ADDENDUM #2

Date:	03.05.2014	Addendum No:	2
Project:	York General Health Care Services Hospital Addition And Remodel	Project No:	24902
To:	Jake Kulhanek	Firm:	Sampson

**DEMOLITION
PLAN - LEVEL 1**

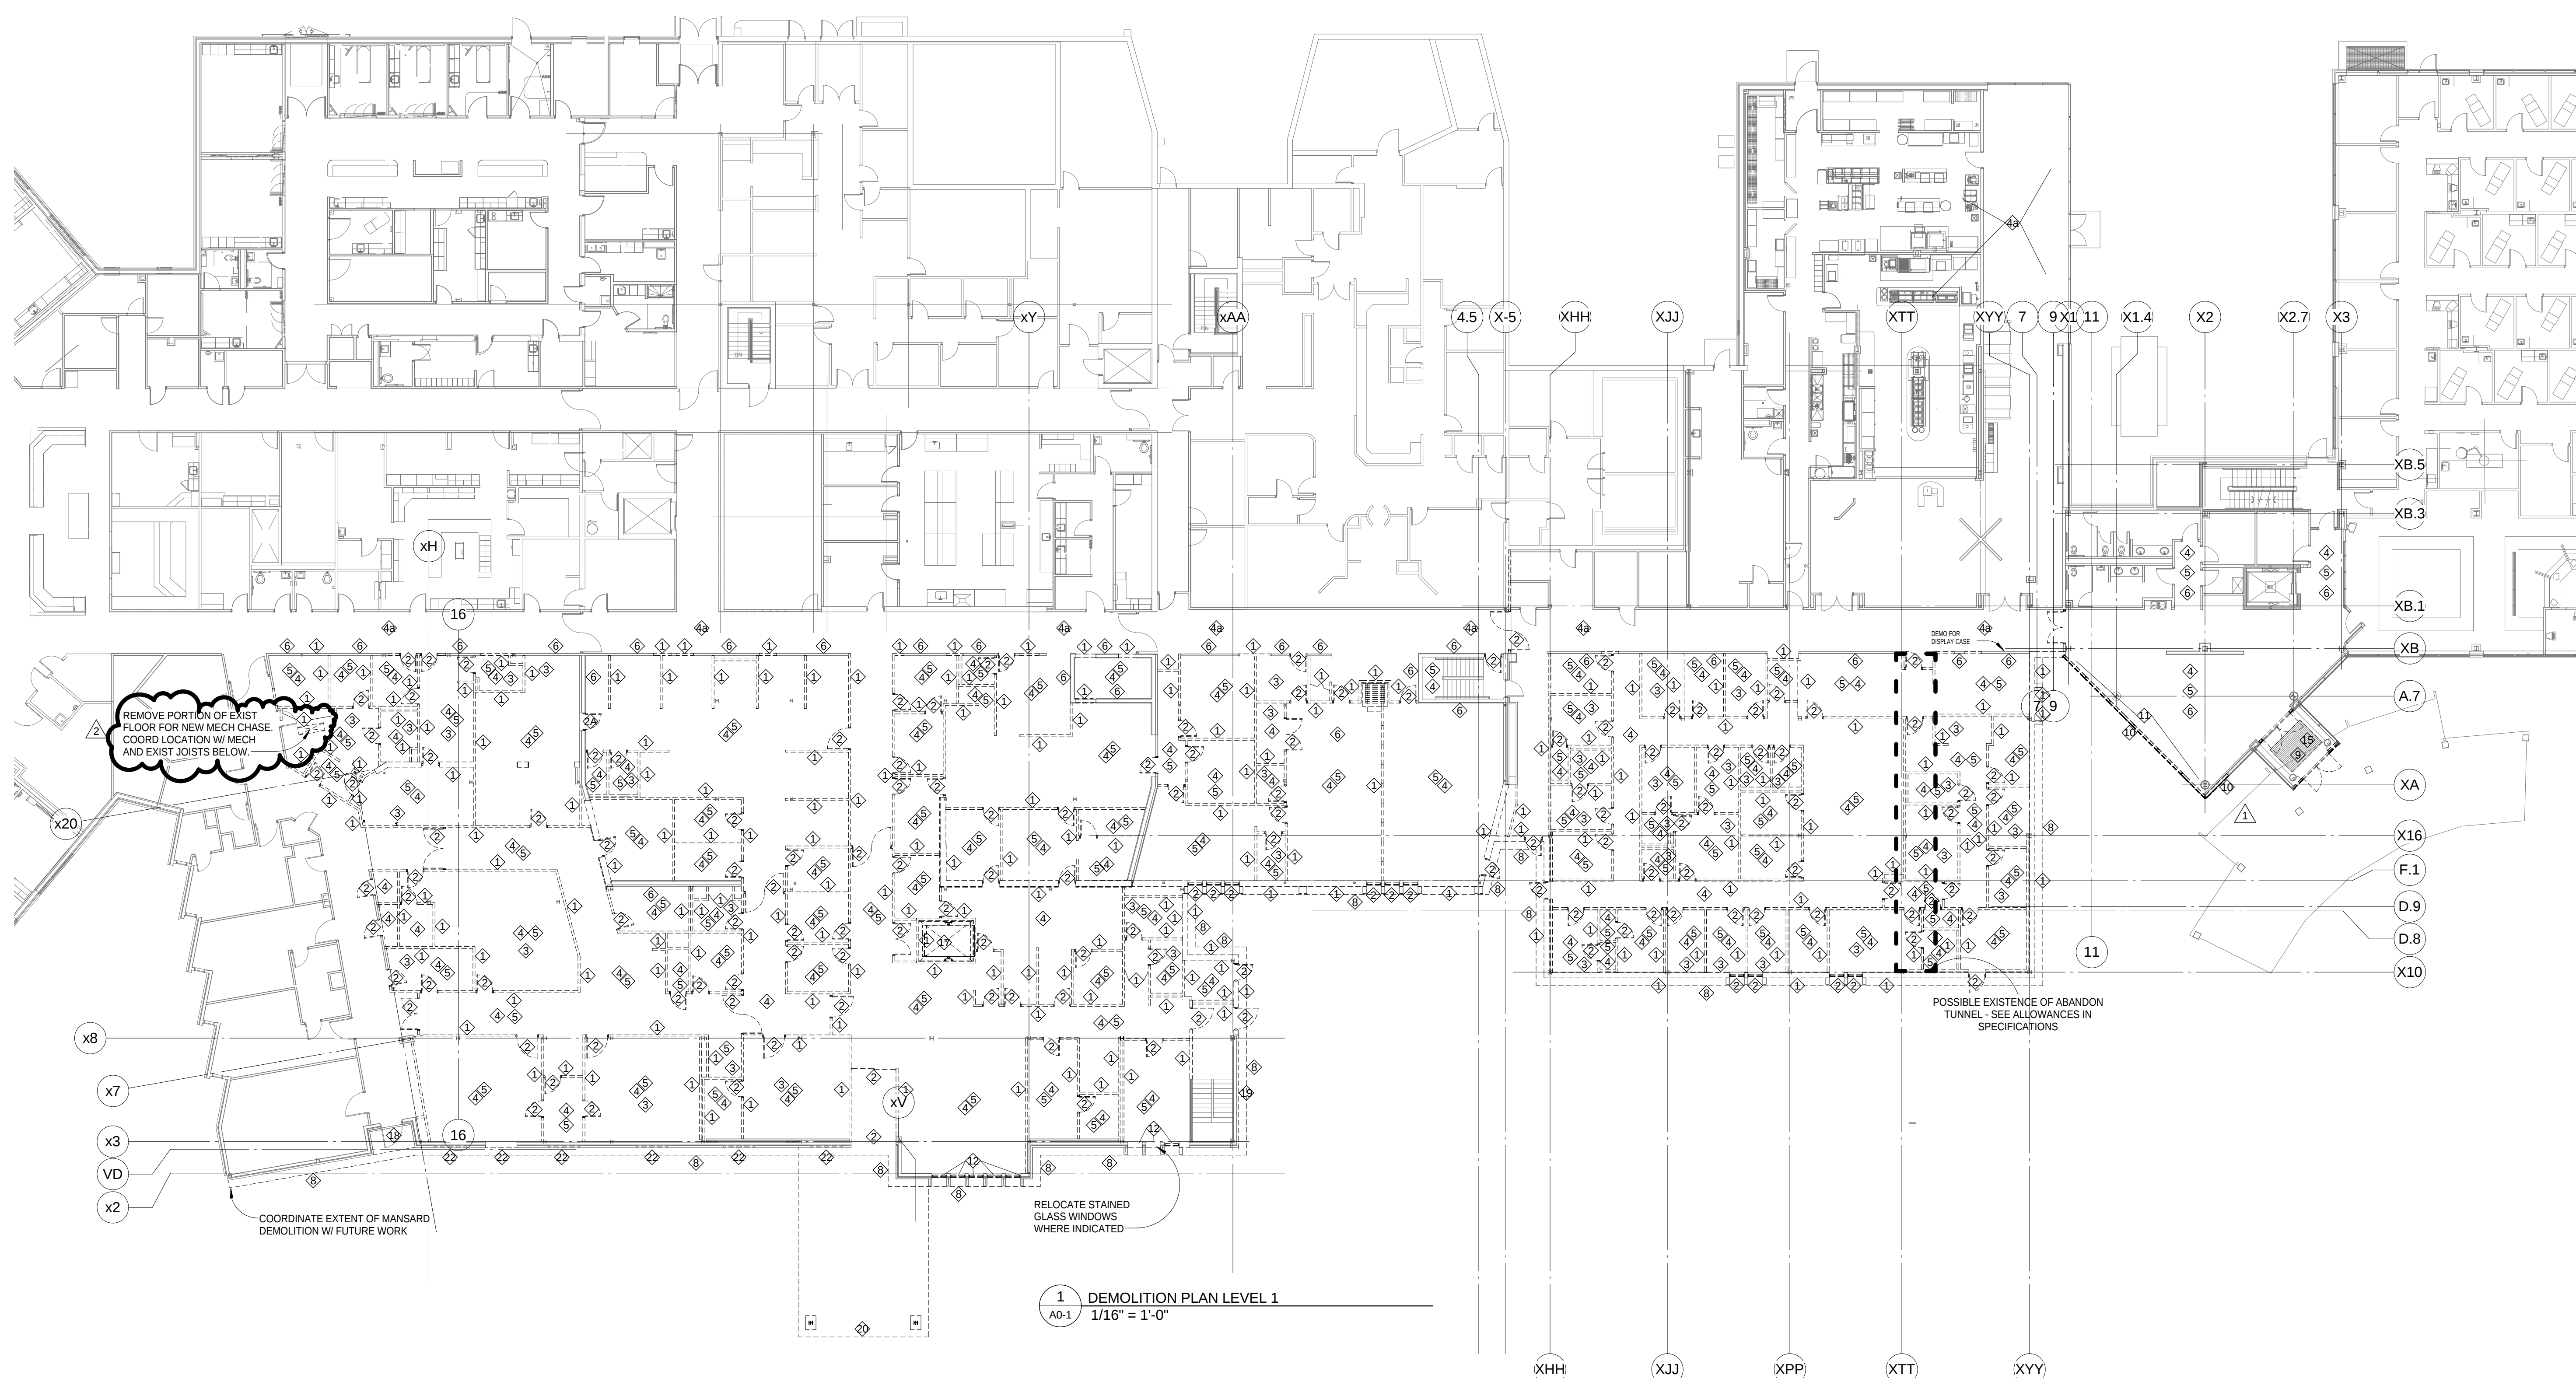
1. Sheet A0-1, DEMOLITION PLAN – LEVEL 1. (Reissue sheet in its entirety):
 - a. North end. Add partial floor removal.
2. Sheet A0-3, GUIDE PLAN – LEVEL 1. (Reissue sheet in its entirety):

1 GUIDE PLAN LEVEL 1
A0-3 1/16" = 1'-0"

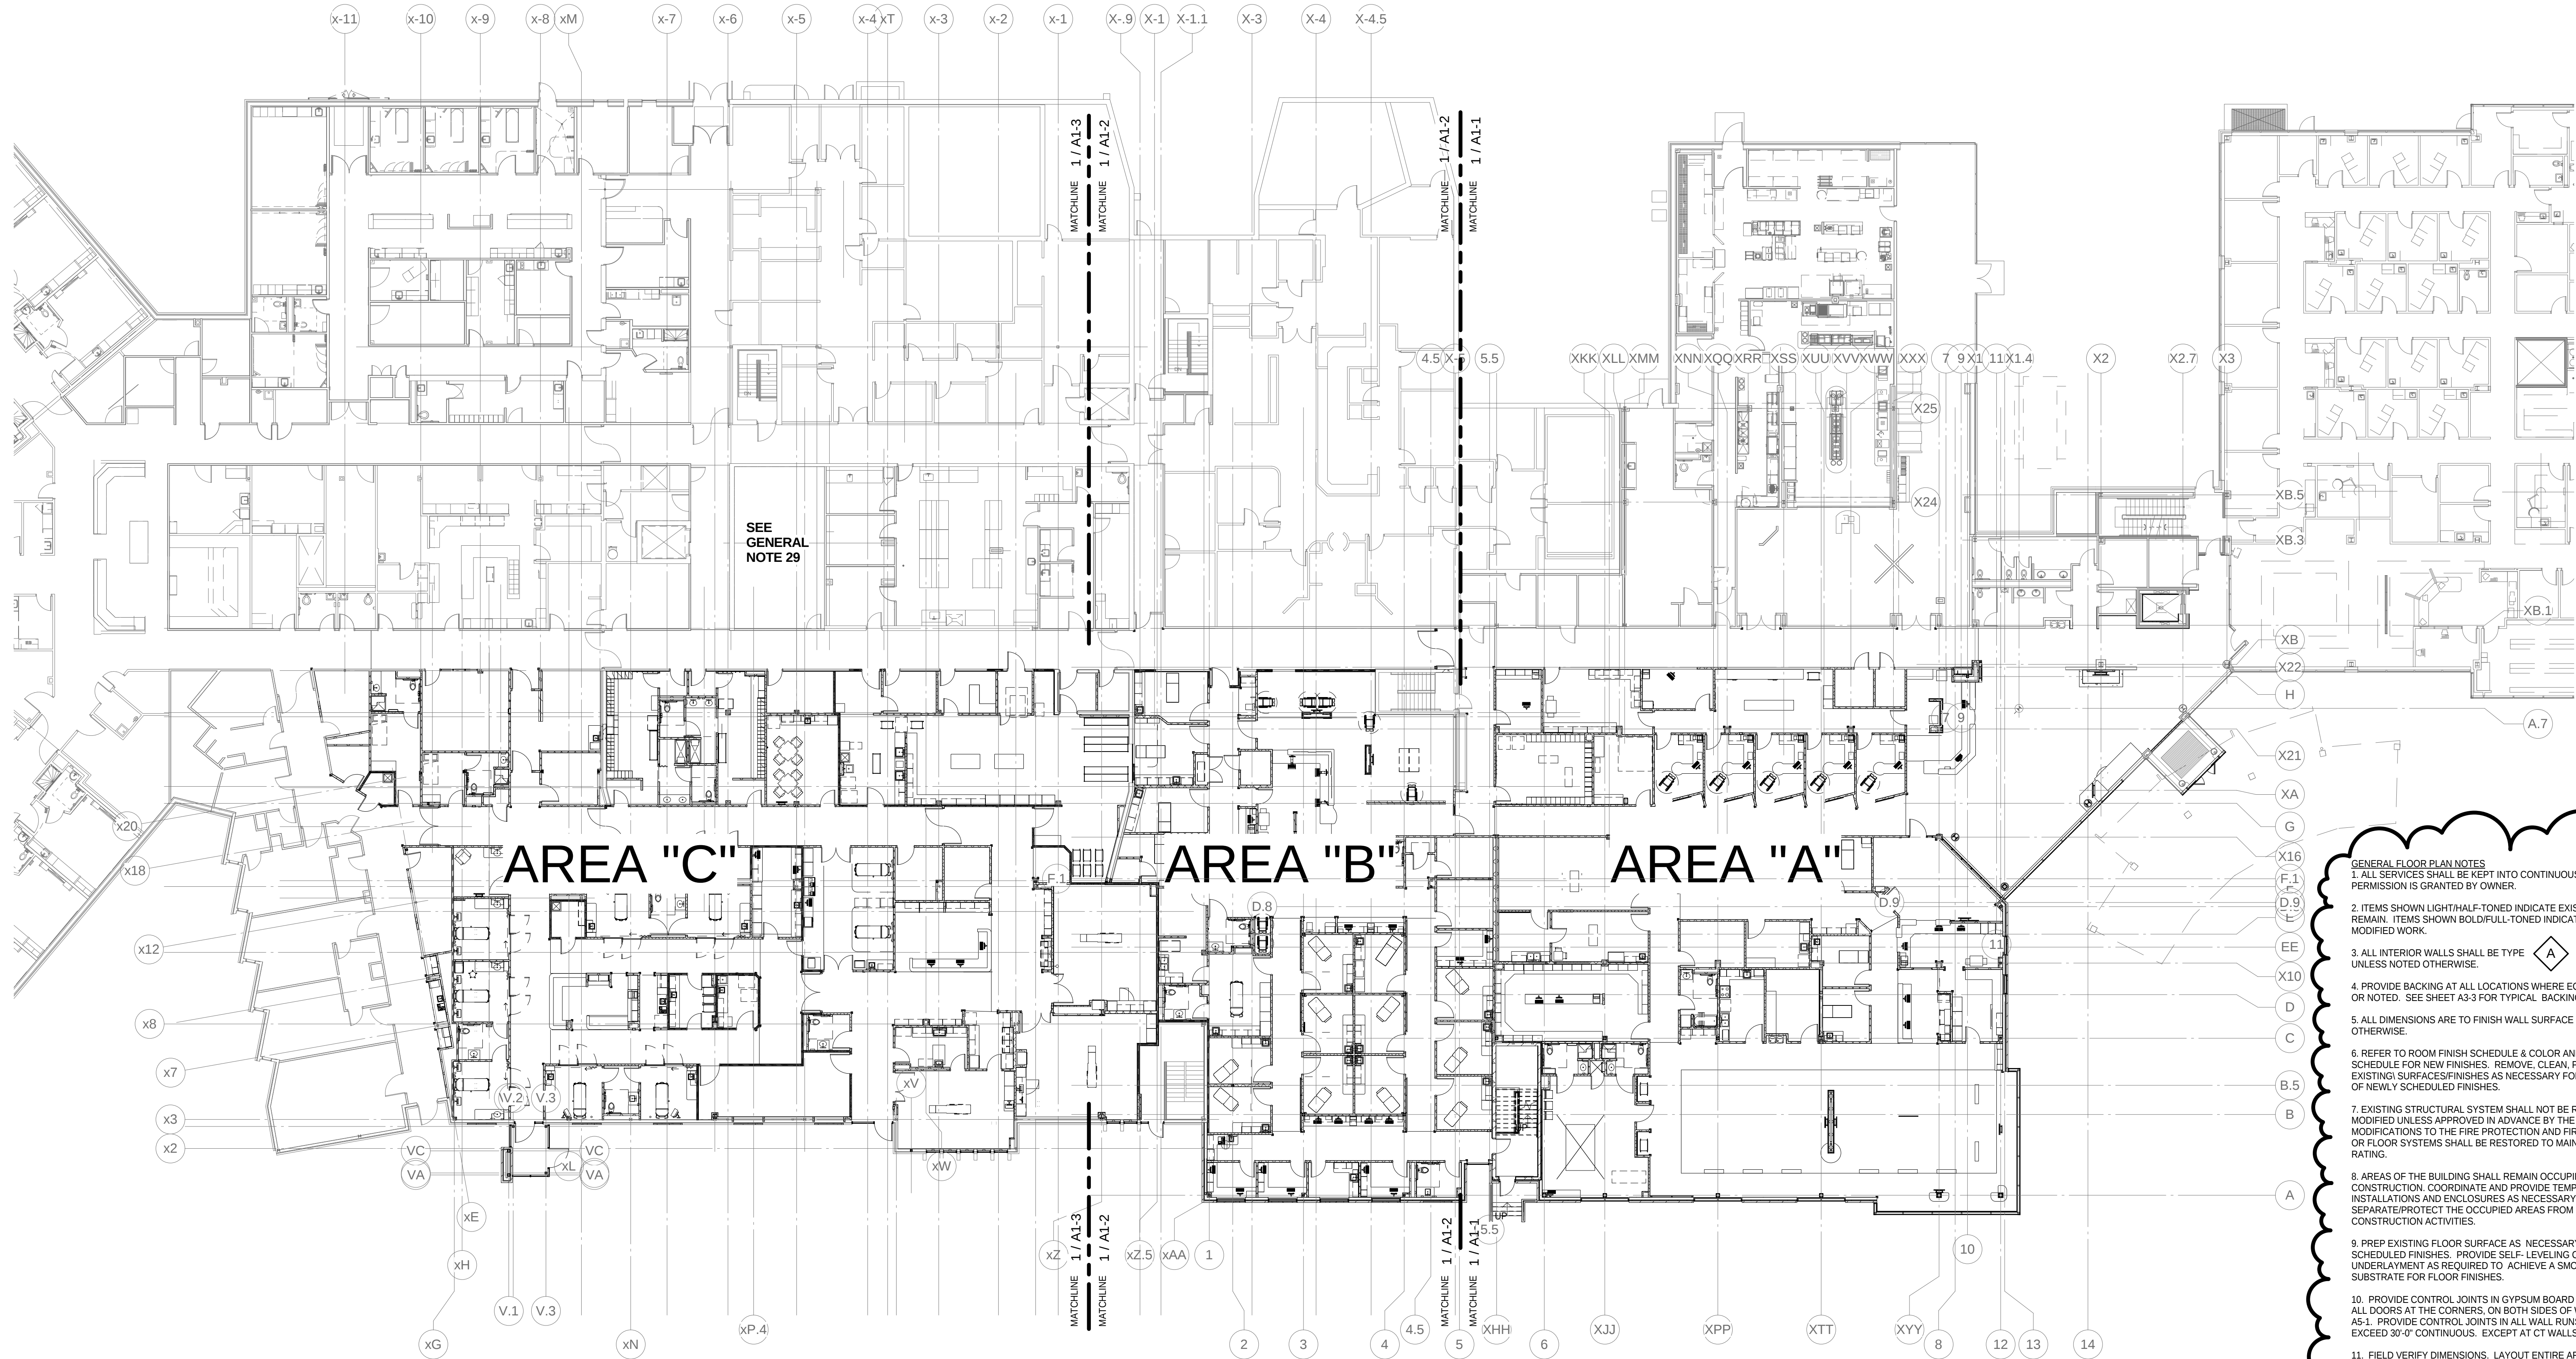
- a. Add “GENERAL FLOOR PLAN NOTES”
3. Sheet A1-3, FLOOR PLAN – AREA “C”. (Reissue sheet in its entirety):
 - a. OFFICE 1460. Modify plan to form stud wall chase at south end.
